Access Compliance Report

Public Rights-of-Way

(Curb Ramps)

Intersection ID: N/A	Main Street: S_COLLEGE_ST	Cross Street: E_TRADE_ST	Location: NE
ADA ID: 0EB9712D003B	Ramp Type: BlendTrans1	Initial Pass/Fail: Fail	Overall Compliance: No
Severity Score: 8.75			
Codes/Mitigation Info/Possible Solution		Field Measurements/Component Compliance

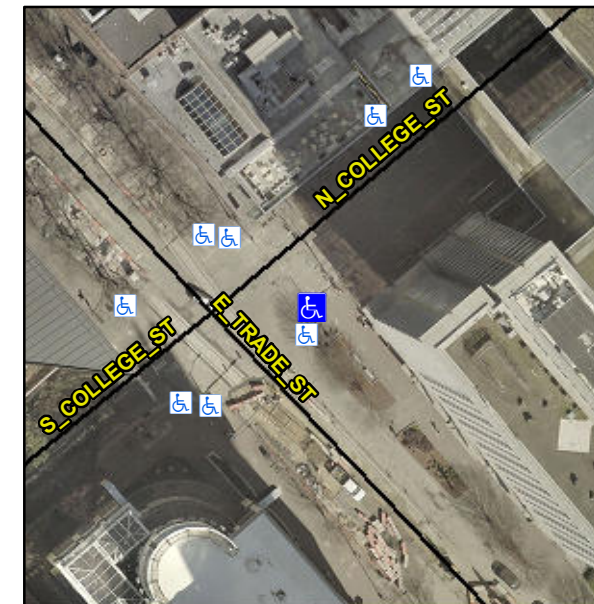
Not Found, R304.5.1

Compliance	Description	Data	Compliance	Description	Data
N/A	Ramp Length (in)	27.0	Yes	BlendTrans Slope (%)	4.5
No	Ramp Width (in)	43.0	Yes	BlendTrans XSlope (%)	0.3
N/A	Flare Type LT	N/A	N/A	Flare Type RT	N/A
N/A	Flare Slope LT (%)	N/A	N/A	Flare Slope RT (%)	N/A
N/A	Flare Traversable LT?	N/A	N/A	Flare Traversable RT?	N/A
N/A	Landing Length (in)	N/A	N/A	DWS Provided?	N/A
N/A	Landing Width (in)	N/A	N/A	DWS Contrast?	N/A
N/A	Landing Slope (%)	N/A	N/A	DWS Length (in)	N/A
N/A	Landing X Slope (%)	N/A	N/A	DWS Full Width?	N/A
N/A	Landing Curb? (Y/N)	N/A	N/A	DWS Offset (in)	N/A
N/A	Shared Landing?	N/A			
N/A	Gutter Ponding?	N/A	N/A	Gutter Slope (%)	N/A
N/A	Gutter Lip Ht (in)	N/A	N/A	Gutter X Slope (%)	N/A
N/A	Painted X Walk1?	Yes	N/A	Painted X Walk2?	N/A
	X Walk 1 Direction	To NW		X Walk 2 Direction	N/A
	X Walk 1 Width (in)	109.0		X Walk 2 Width (in)	N/A
	X Walk 1 Slope (%)	4.6		X Walk 2 Slope (%)	N/A
	X Walk 1 X Slope (%)	0.4		X Walk 2 X Slope (%)	N/A

N/A	Ramp inside XWalk1?	Yes	N/A	Ramp inside XWalk2?	N/A
	Road Slope (%)	0.4		Clear Space?	N/A
	Road X Slope (%)	4.6	N/A	Clear Space to XWalk (in)	N/A
N/A	Any Obstructions?	N/A	N/A	Storm Grate/Utility Hazard?	N/A
	Obstruction Type			Storm Grate/Utility Type	
		N/A			N/A
			Yes	Surface Condition? (G/P)	Good
			No	Curb Slope (%)	6.3

Remove & Replace Curb Ramp With Two New Directional Ramps or Equivalent.
